SCRUGGS ROAD AREA IMPROVEMENTS
WINDMERE - COMPASS COVE - BERNARD'S LANDING
WATER MAIN EXTENSION & PRIV SITES
PREPARED FOR WESTERN VIRGINIA WATER AUTHORITY
FRANKLIN COUNTY, VIRGINIA

REVISIONS	
DESIGNED BY:	CEP
DRAWN BY:	CEP
CHECKED BY:	JOE & BLR
SCALE:	1" = 30'
DATE:	AUGUST 12, 2022
PROJECT NUMBER:	21-0287
SHEET TITLE:	PLAN AND PROFILE STA 67+00 TO STA 76+20

C1.7
10 OF 14

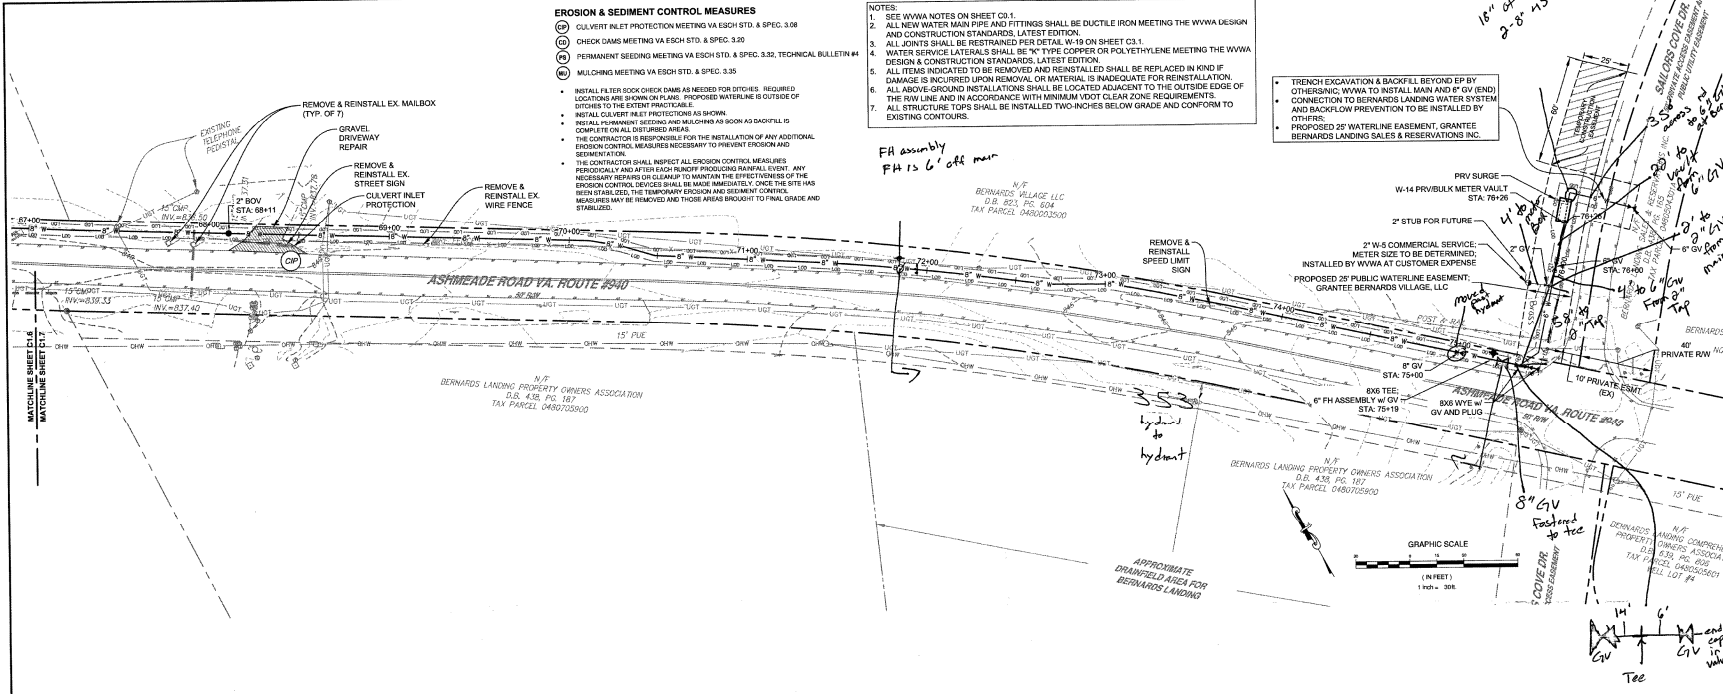
FA assembly
FH is 6' off main
